ADDENDUM #1

ITB #201918 – Construction of Pre-fabricated Metal Training Structure

LIVE FIRE TRAINING STRUCTURE

TITLE:
SITE LAYOUT PLAN

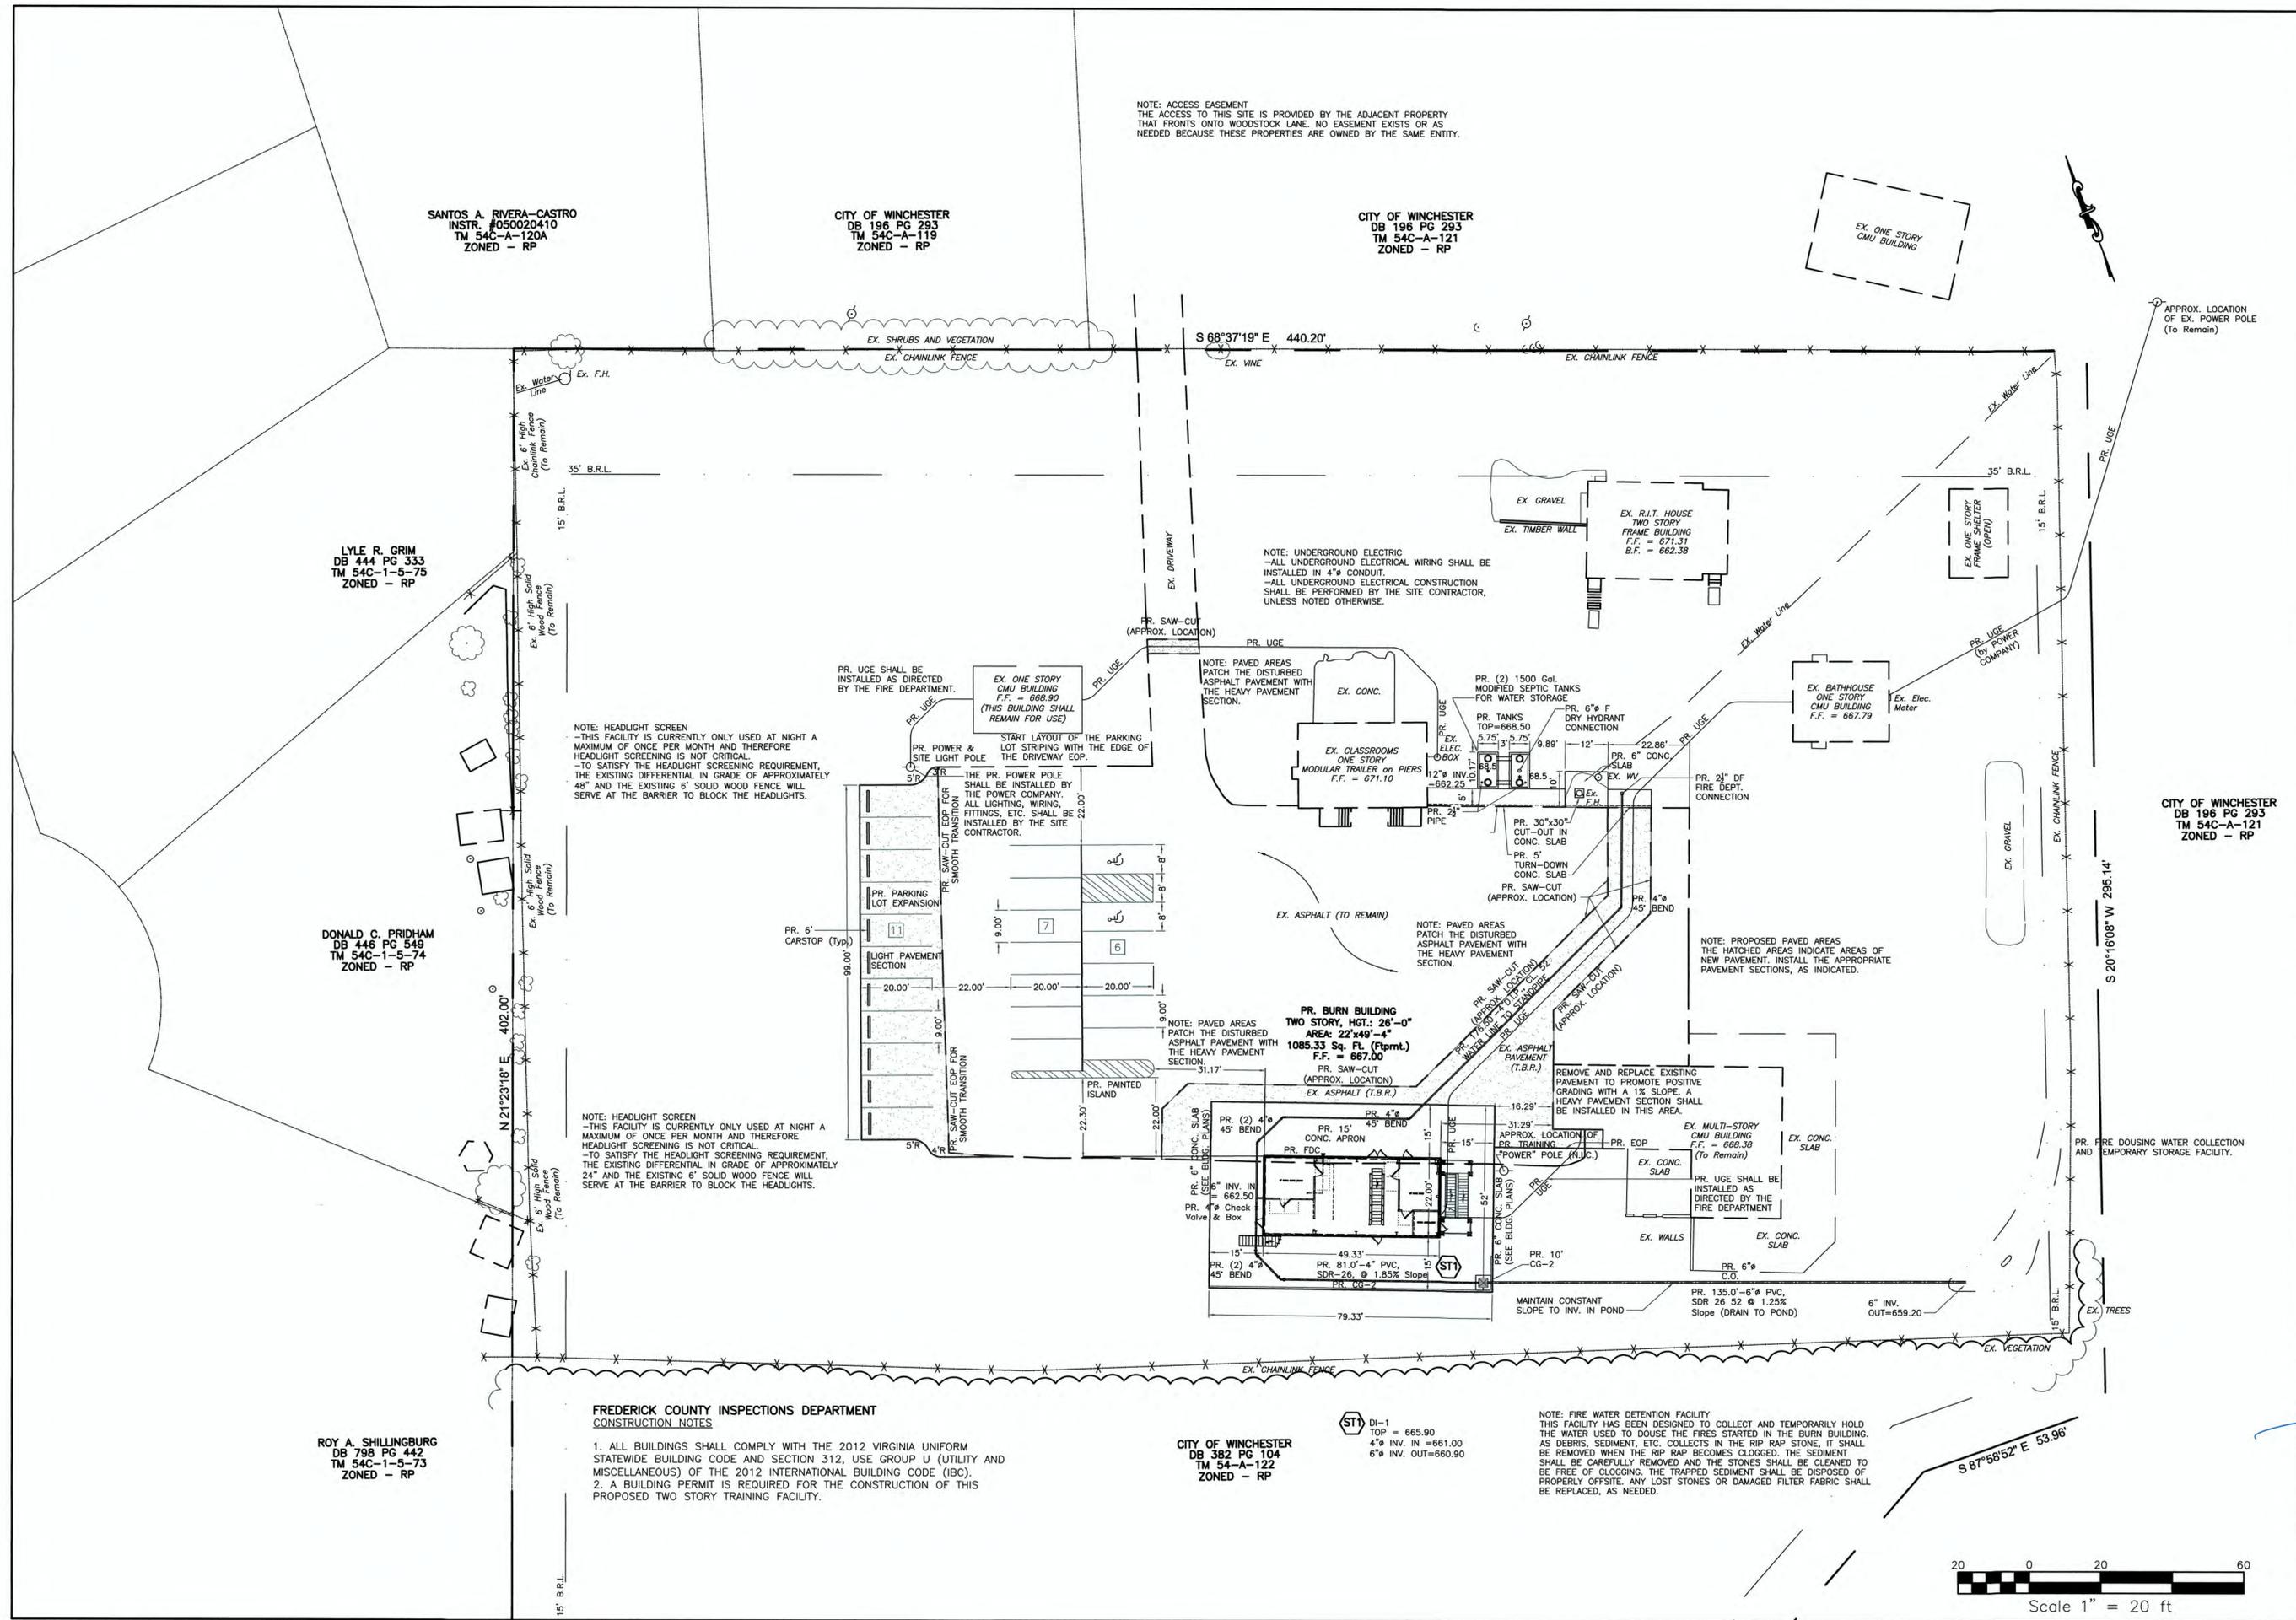
1. The Site Plan Drawings have been revised and are attached this Addendum.
2. Electrical Drawings have been prepared and are attached to this Addendum. There is also a sprinkler connection detail on these drawings.

REVISIONS		NO.	DATE	DESCRIPTION
2	03-18-19			BURN BUILDING RELOCATION
1	05-16-16			AGENCY COMMENTS
		TGP		
		TGP
